APPLICATION NO.	FILING DATE	FIRST NAMED INVENTOR	ATTORNEY DOCKET NO.	CONFIRMATION NO.
10/560,800	05/12/2006	Jiming Li	0815-053671	7396
28289 7590 06/06/2008 THE WEBB LAW FIRM, P.C. 700 KOPPERS BUILDING 436 SEVENTH AVENUE PITTSBURGH, PA 15219				
EXAMINER				
PATEL, VISHAL A				
ART UNIT		PAPER NUMBER		
3676				
MAIL DATE		DELIVERY MODE		
06/06/2008		PAPER

### Office Action Summary

## **DETAILED ACTION**

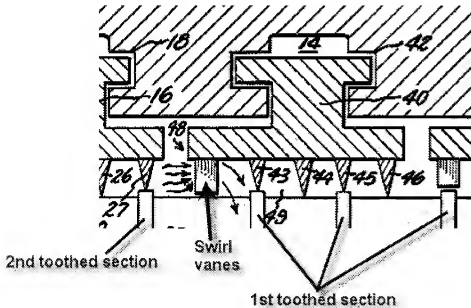
3. Claim 1 is rejected under 35 U.S.C. 103(a) as being unpatentable over Miller (US. 4,420,161) in view of Burnett et al (US. 6,679,681).  
Miller discloses an apparatus having a labyrinth seal having a seal section (section having 43-46) on a stator and swirl vanes (e.g. 37 shown below) on the stator, a shaft (e.g. 10) comprising a first toothed section and a second toothed section, a cylindrical surface (surface between 32 and 50, 32 is part of the second toothed section and 50 is part of the first toothed section) of a diameter less than the outer edge of the teeth of the toothed sections and the seal section having teeth (43-46).
